FIELD OBSERVATION REPORT

West Hardin Middle School, 202280 -CA8

Report No: 28

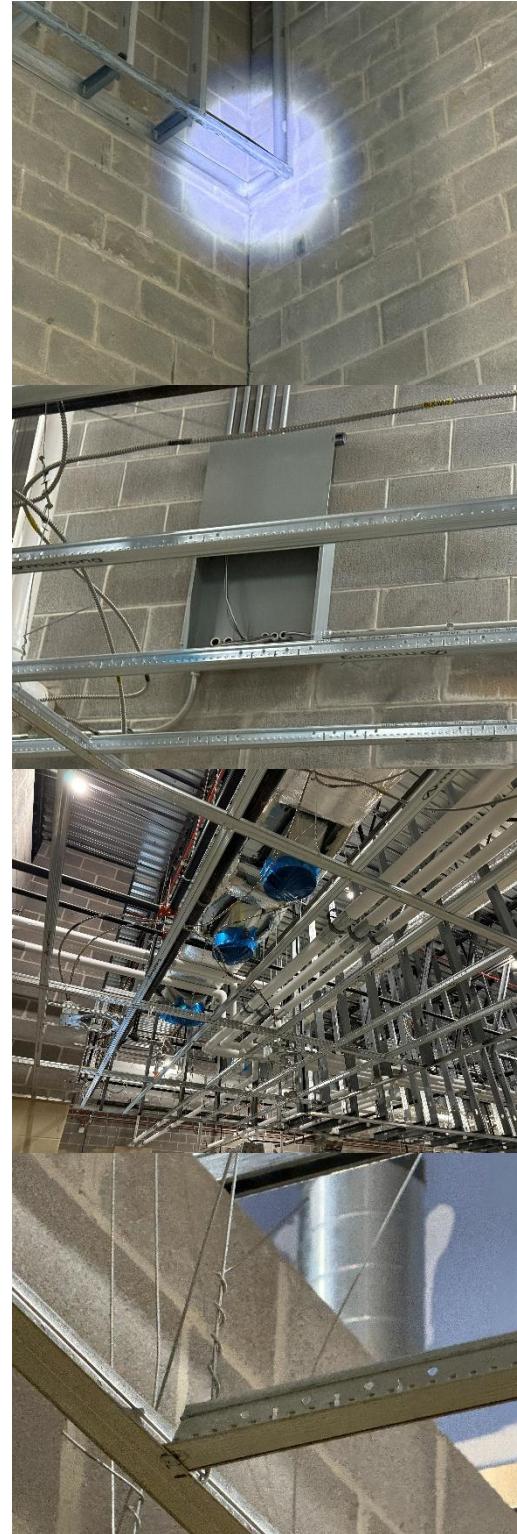
- n) We also looked at places where piping and conduits penetrated through fire resistant rated walls. Jeremy needs to confirm if the electricians can continue to use mortar in block walls as a penetrant seal with the state building inspector. Also refer to TEK Note 3A from the National Concrete Masonry Association, attached.
